Commonwealth Edison

December 6, 1983

Subject: Byron Generating Station Units 1 and 2
Braidwood Generating Station Units 1 and 2
Dropped Rod Reanalysis
NRC Docket Nos. 50-454, 50-455, 50-456,
and 50-457

Revised FSAR Pages Incorporating New
Dropped Rod Analysis

Figure 15.4-12a (Sheet 1 of 2)
Typical Transient Response to a Dropped
RCCA (or RCCA's) in Automatic Control

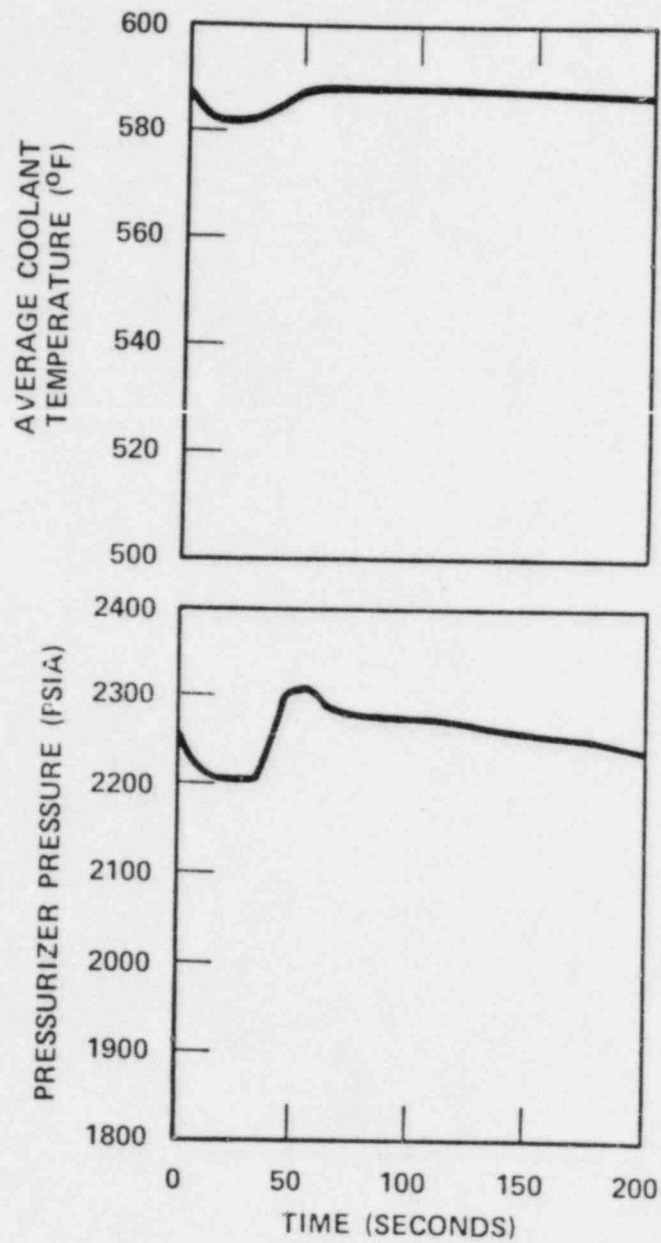
For a dropped RCCA event in the automatic rod control mode, the rod control system detects the drop in power and initiates control bank withdrawal. Power overshoot may occur due to this action by the automatic rod controller after which the control system will insert the control bank to restore nominal power. Figure 15.4-12a shows a typical transient response to a dropped RCCA (or RCCA's) in automatic control. Uncertainties in the initial condition are included in the DNB evaluation as described in Reference 9. In all cases, the minimum DNBR remains above the limit value.
